CONTRACT NO. 1800

WET WEATHER PUMP STATION

ADDENDUM NO. 12

Attachment C - Addendum No. 12 Drawing – 22” x 34” (1 page)

Addendum No. 12 Drawings

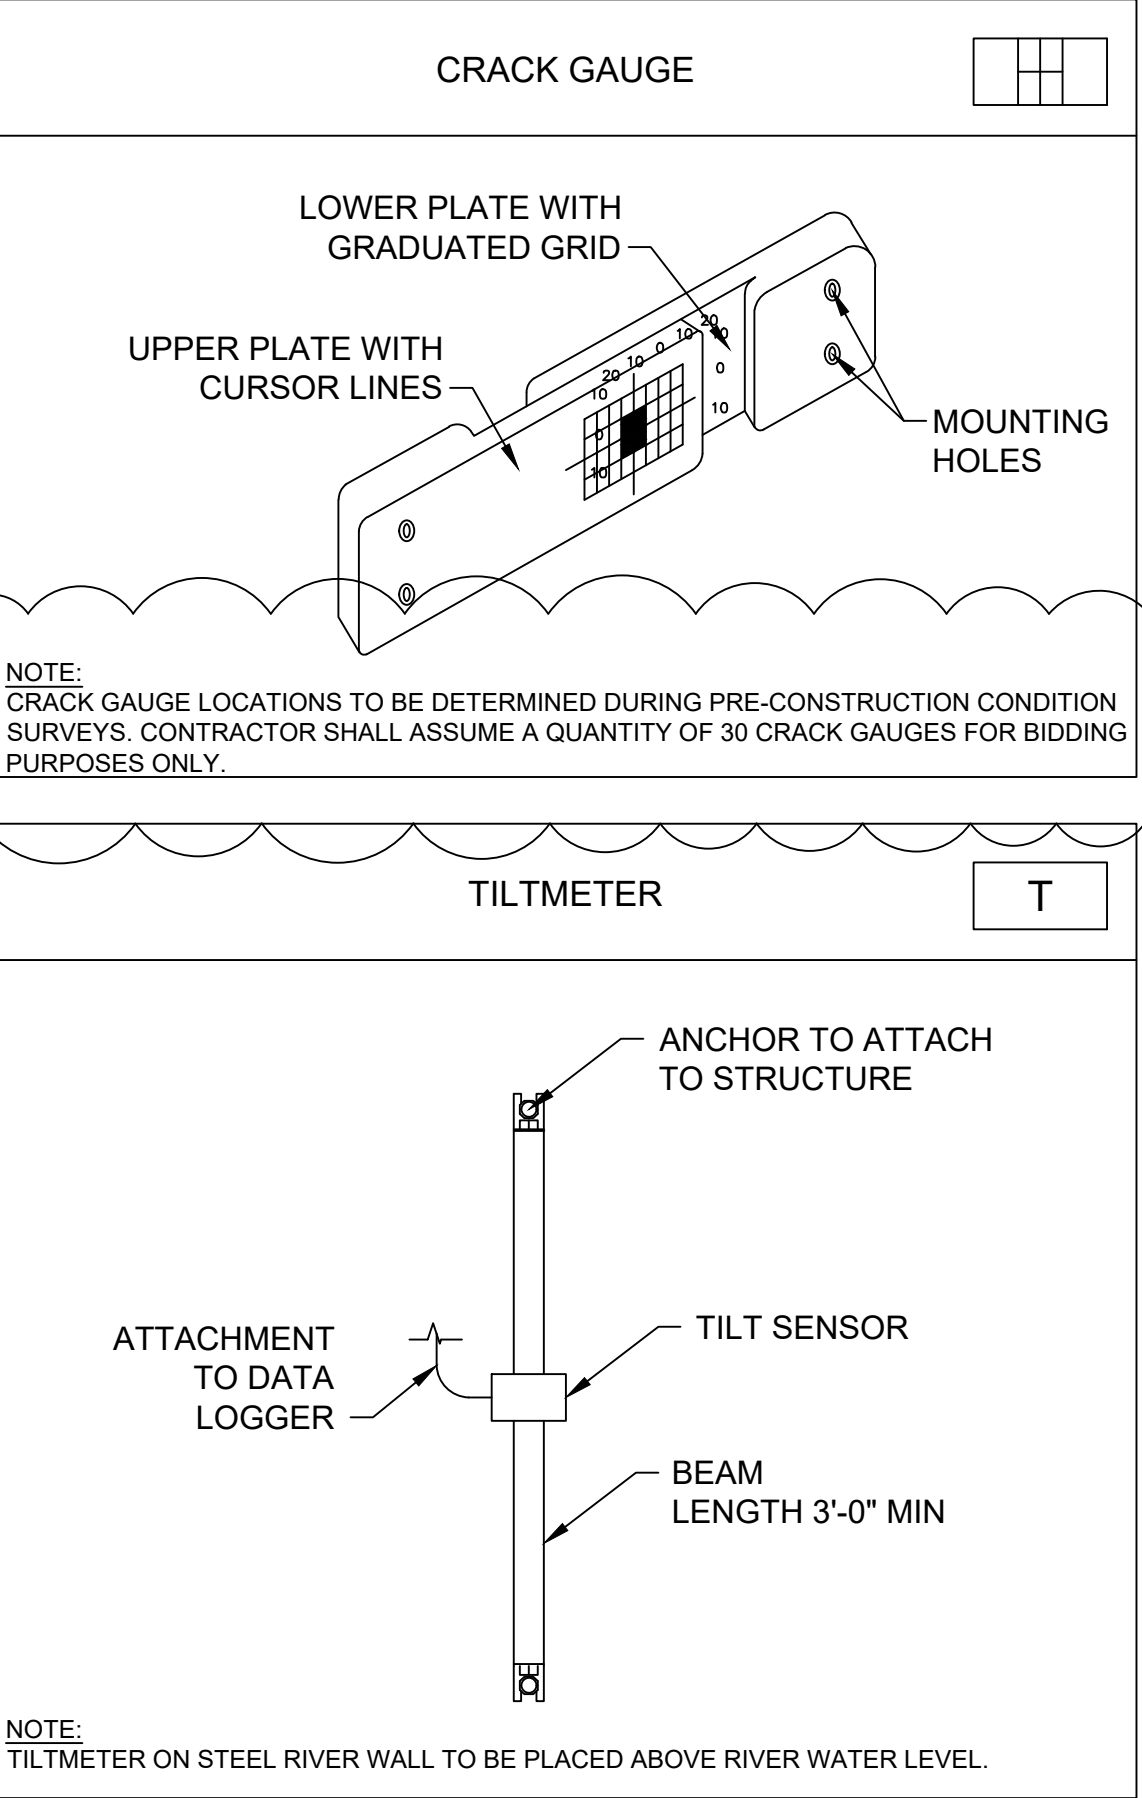
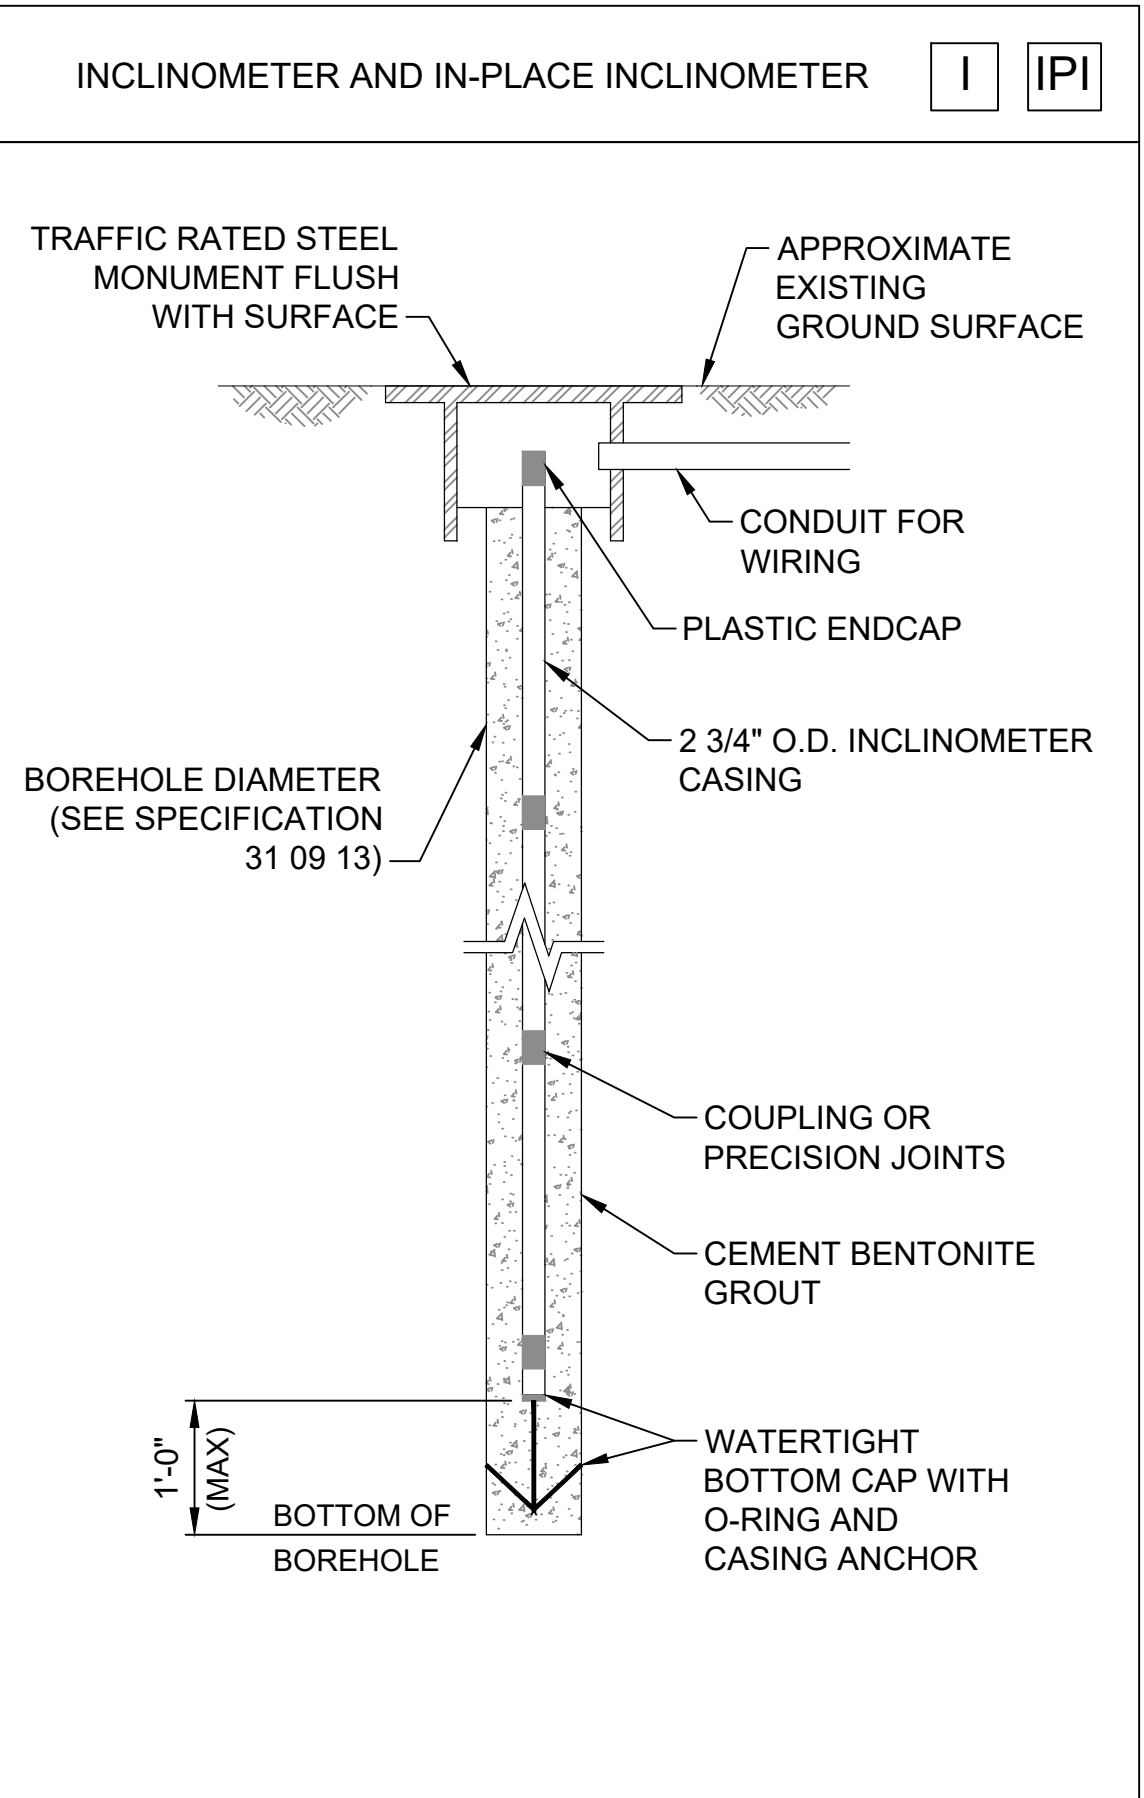
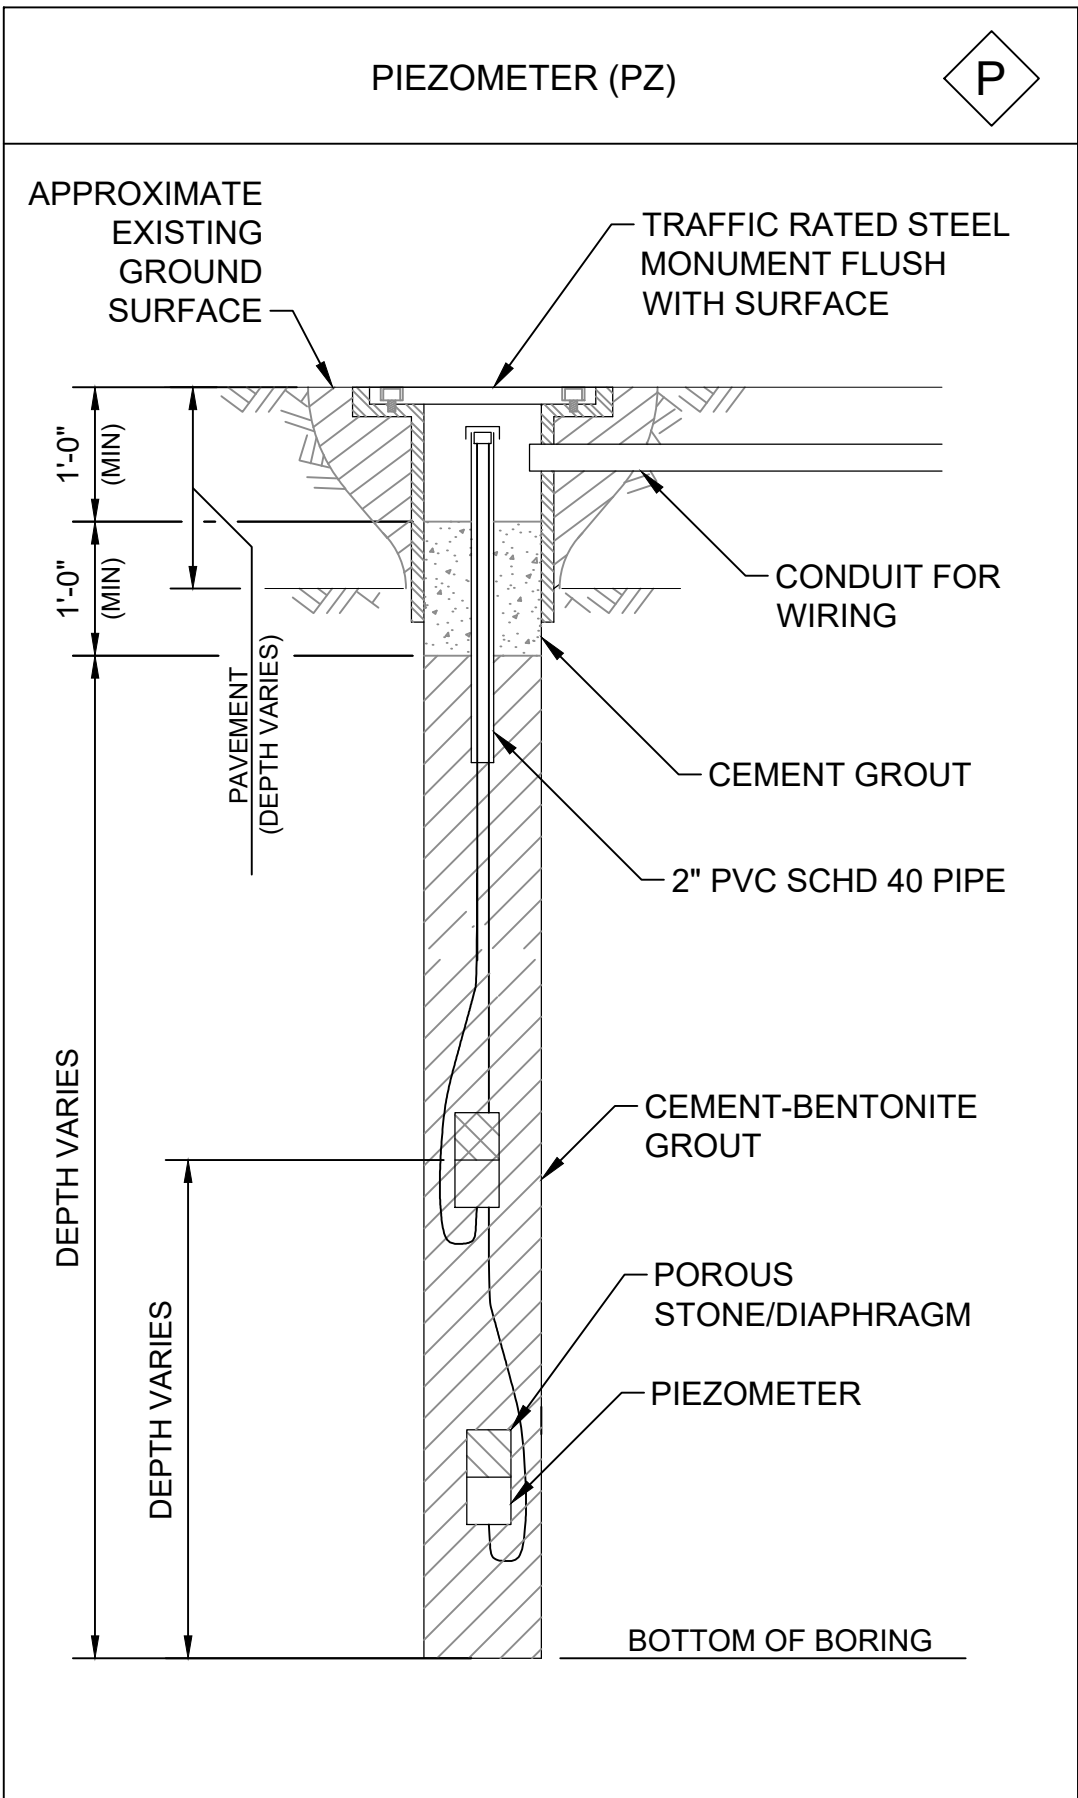
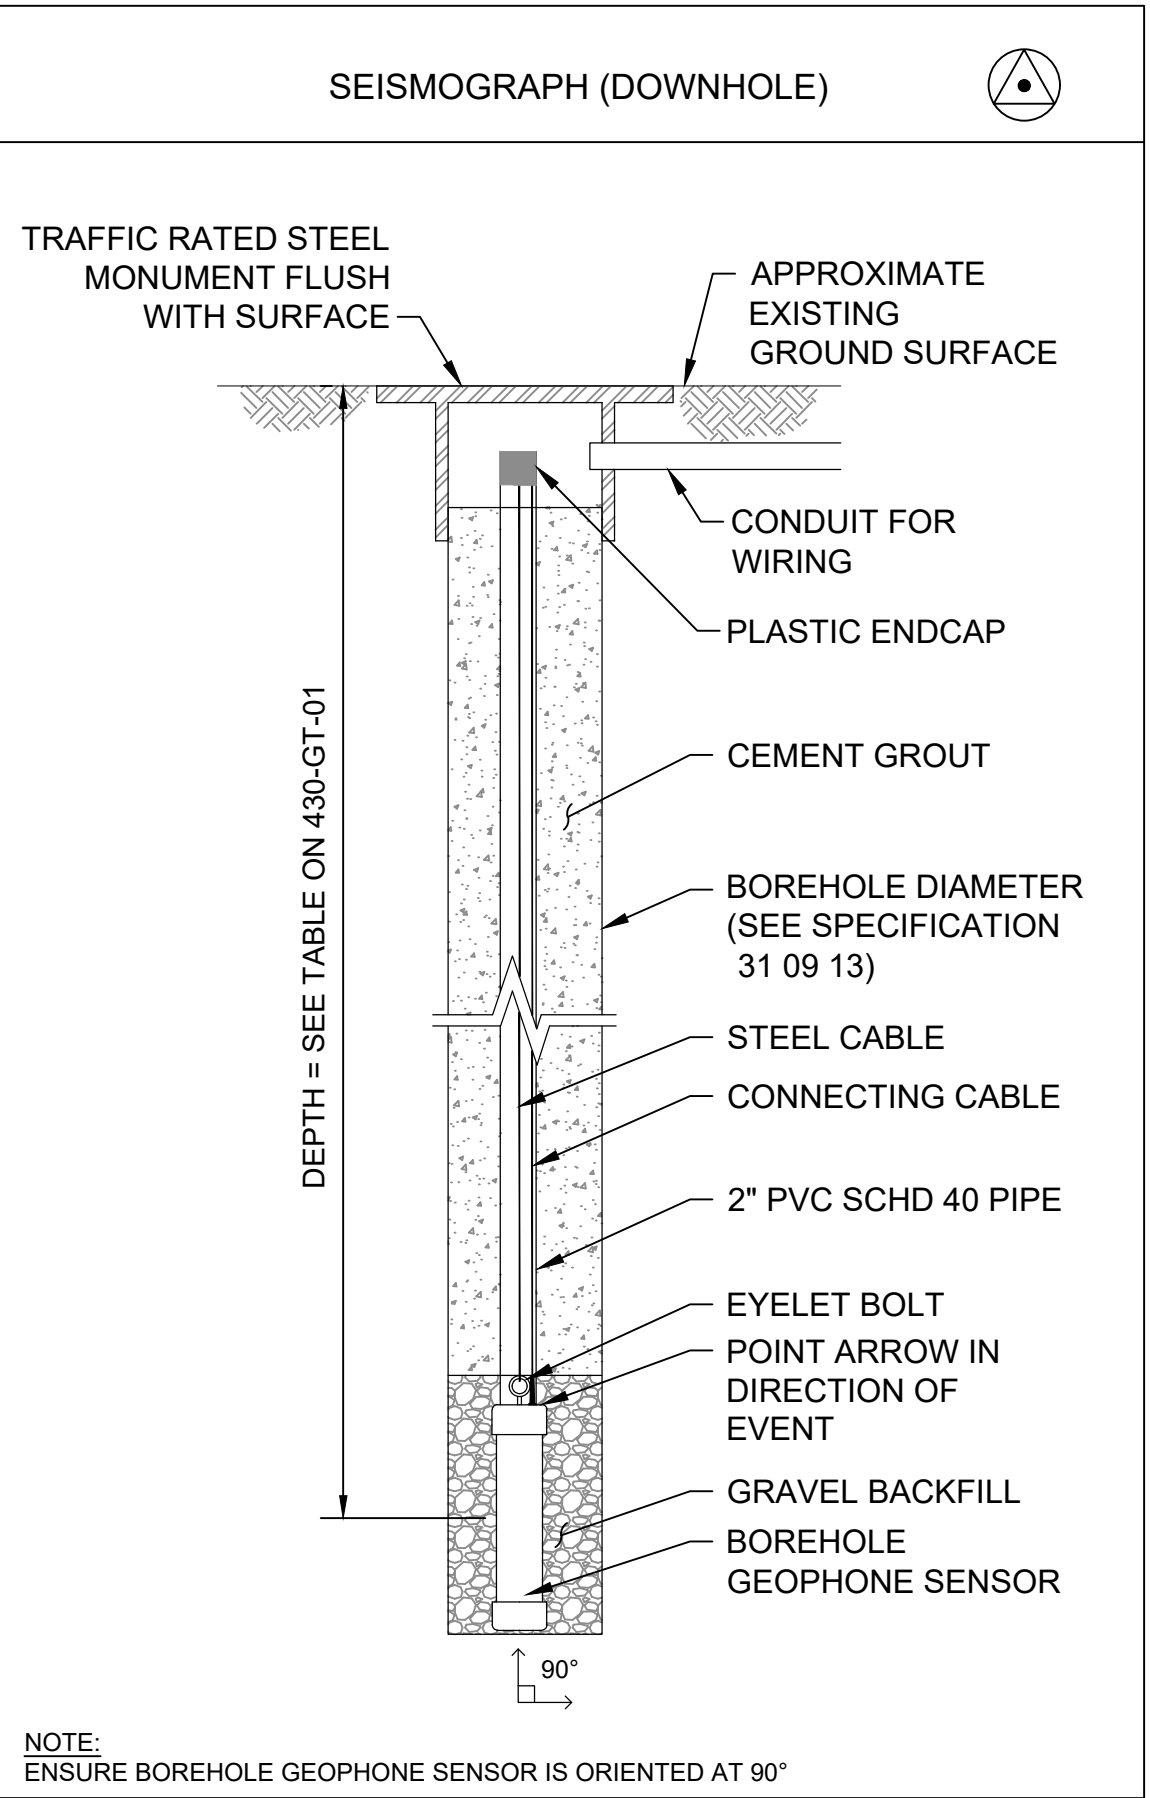
4.1 **REPLACE** Sheet 430-GT-04 with Sheet 430-GT-04 Rev.01, refer to Attachment C.

Designed by: G. ASPIRAS	REVISION				
	REV No.	DATE	DESCRIPTION	APPV	
	0	5/16/25	ISSUED FOR BID	PDC	
Drawn by: P. CAMPBELL	1	9/18/25	ADD. 12 - UPDATED NOTE ON CRACK GAUGES	PDC	
Checked by: P. CAMPBELL
